Re: Florida Power & Light Company
Proposed Turkey Point Units 6 and 7
Docket Nos. 52-040 and 52-041
Supplemental Response to NRC Request for Additional Information Letter No. 72
(eRAI 6985) SRP Section 11.02 - Liquid Waste Management Systems

NRC RAI Number: 11.02-6-6 (eRAI 6985)

Question 6

Figure 1 – Proposed Locations of Deep Injection Wells and Dual Zone Monitoring Wells

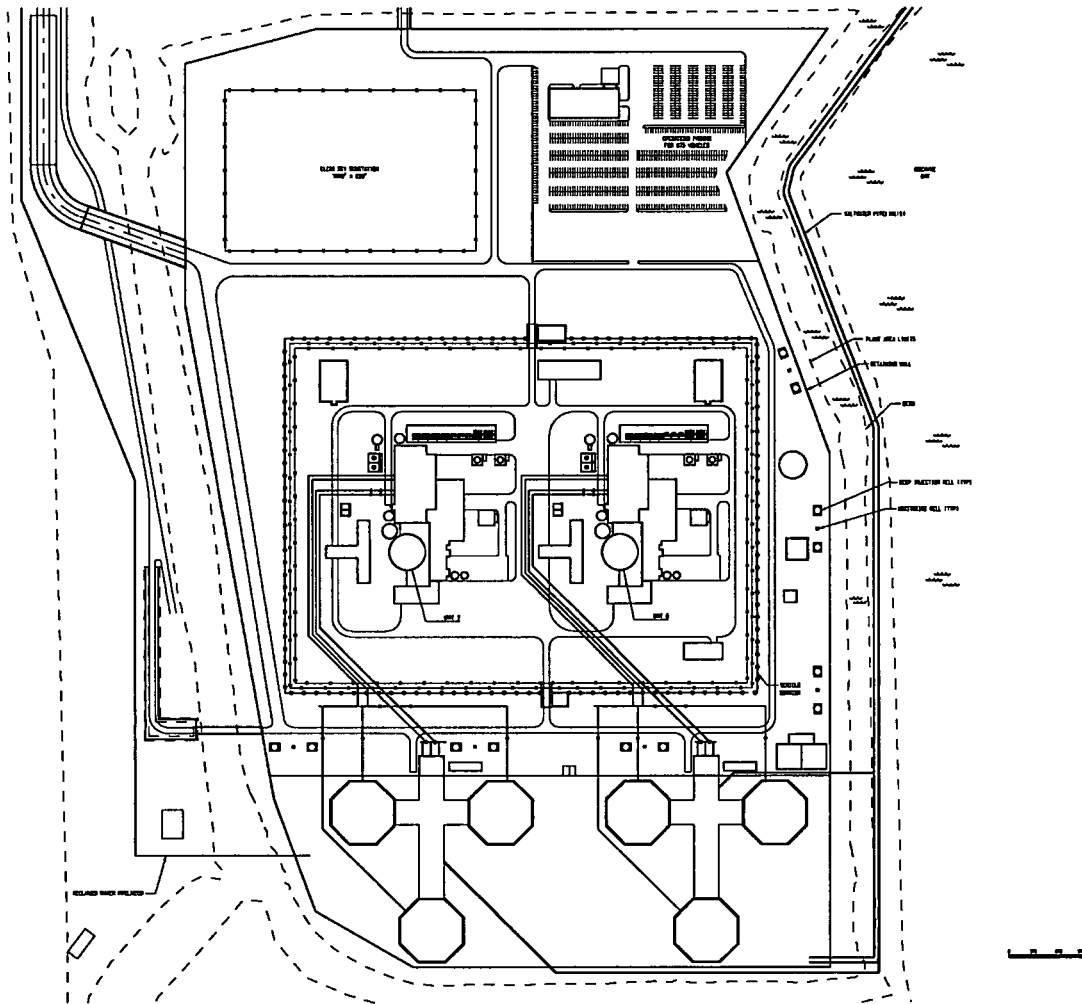
With respect to injection flow and dilution flow rates, the applicant is requested to reconcile differences in stated flow rates and citations for the location of such information. For example, FSAR Tier 2, Rev. 4, Section 11.2.3.5 refers to FSAR Section 9.2.6.2.1 for details on deep well injection, but this FSAR section addresses the treatment of sanitary wastes. While FSAR Tier 2, Rev. 4, Section 11.2.3.5 identifies dilution flow rates for the disposal of liquid effluents by deep well injection in assessing radiological impacts, it does not refer to a specific FSAR section for design specific information, such as FSAR Tier 2, Section 9.2 or 10.4.5. A review of ER, Rev. 4, Section 5.2.3.2.4 indicates that the stated flow rates are 12,500 gpm and 58,000 gpm, which are consistent with ER Rev. 4, Table 3.3-1 under normal and maximum cases. However, FSAR Rev. 4, Section 2.4.12.2.1.3 refers to peak and operational injection rates, with a stated 14,000 gpm for reclaimed water and 62,500 gpm for seawater as implied normal operational flow rates. These injection rates are driven, in part, by FLDEP specifications on maximum linear velocities and friction loss and injection pressures, but such details and limitations on the design basis are not described in the FSAR. Accordingly, it is not

There are two sources of makeup water for the circulating water system (CWS) – reclaimed water (primary) and saltwater from the radial collector wells (backup). The saltwater backup source is expected to be used not more than 60 days in any consecutive 12-month period. The saltwater backup source will be used only when the primary water source is not of sufficient quality or quantity. The deep injection well flow is comprised of the blowdown from the cooling tower circulating water system, additional dilution from the Reclaimed Water Treatment Facility (primary source only), and discharge flow from the sanitary waste treatment plant and wastewater retention basin during normal plant operation. Figure 1 depicts the proposed locations of the deep injection wells and dual zone monitoring wells.

Figure 2 – Liquid Waste Stream Collection and Disposal Schematic (Typical)

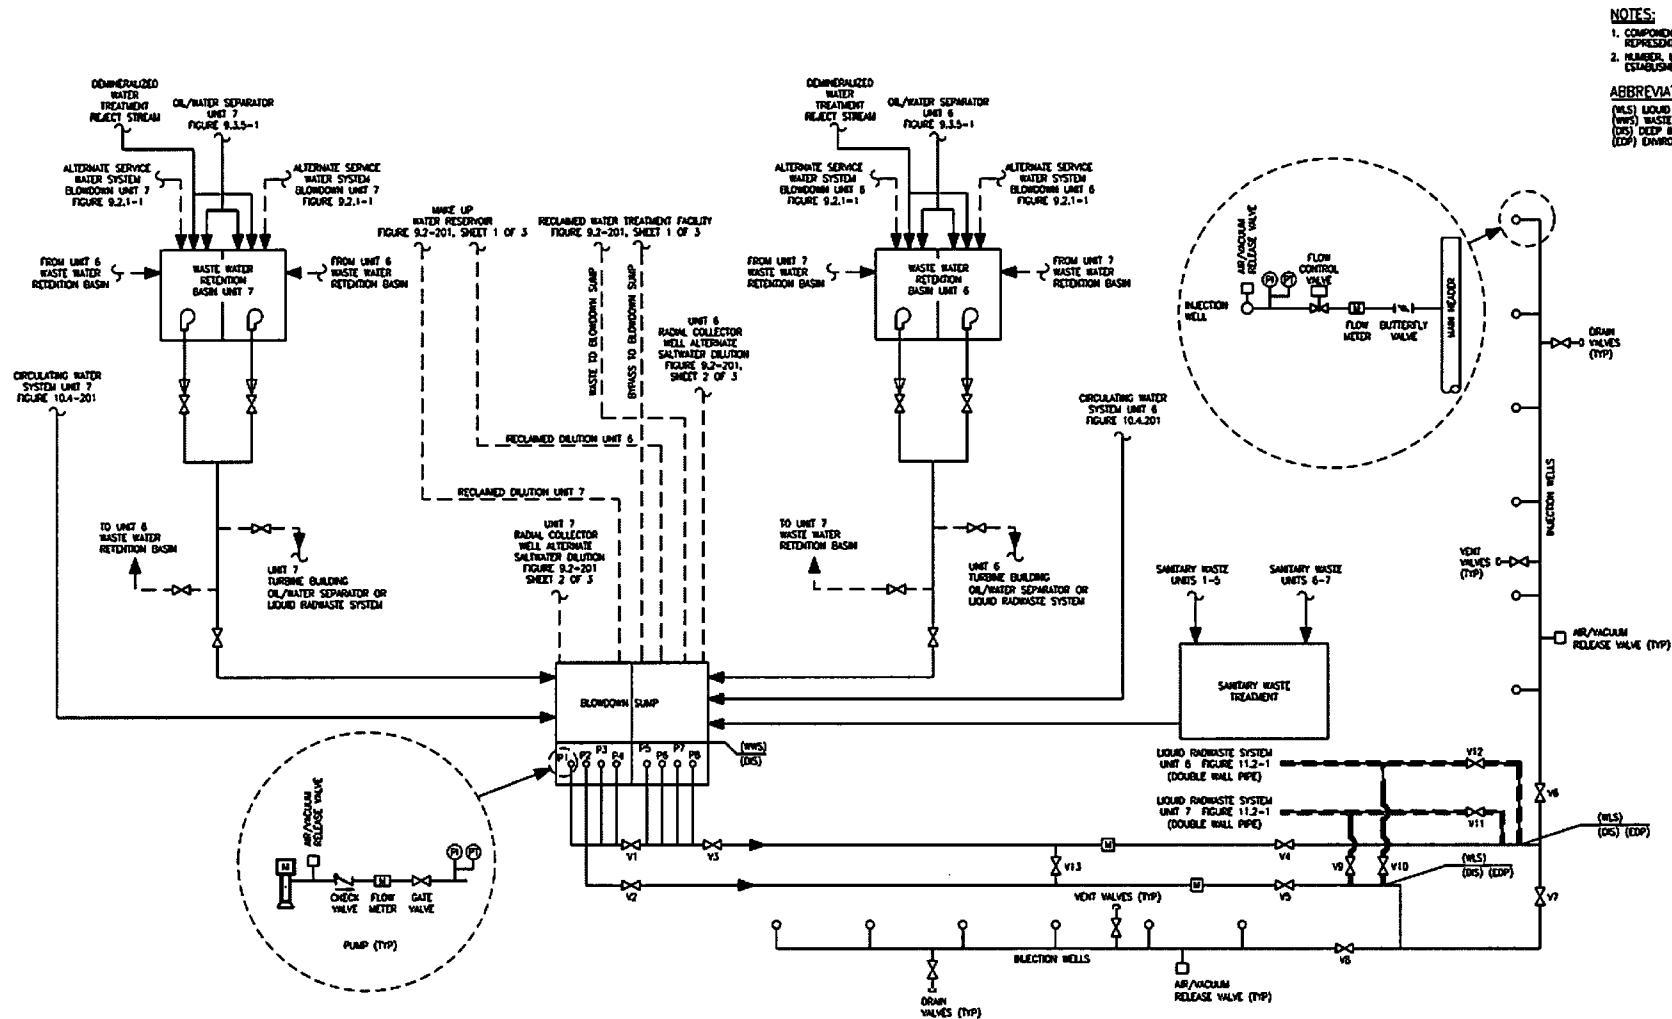
clear which injection flow rates form the FSAR design basis, and whether the stated injection flow rates reflect the information presented in FPL's September 2012 report on the construction and testing of the first exploratory well. The applicant is requested to review and revise the FSAR and include in its revision a description of the DWI system and flow schematics, essential operational features and characteristics, and design basis of deep well injection flow rates when using reclaimed water and seawater and qualify the operational conditions for each, as expected normal operation versus peak or maximum conditions, and their justifications in modeling radiological impacts.

Figure 2 is a schematic which depicts all of the waste streams relevant to the deep well injection system (DIS). Figure 2 of the RAI response will be used to replace the system description in FSAR Figure 9.2-203 and will be titled the same as Figure 2. FSAR Figure 9.2-203 has been revised to include the typical installation locations for system air/vacuum

release valves, vents, and drains. The DIS piping system connecting the injection wells to the pump station has not been designed; therefore, the final location and spacing of the air/vacuum release valves, vents, and drains on the piping system have not been determined. The estimated makeup water flow rate is 38,400 gpm when reclaimed water is used for CWS makeup. Based on four cycles of concentration in the CWS and additional dilution to maintain 10 CFR Part 20 criteria (6000 gpm dilution flow per AP 1000 Unit), the resultant total flow to all of the deep injection wells is approximately 12,500 gpm (normal) and approximately 13,000 gpm (maximum) for both units. A minimum of two deep injection wells will be used resulting in estimated normal and maximum flow rate per injection well of approximately 6250 gpm and 6500 gpm, respectively.
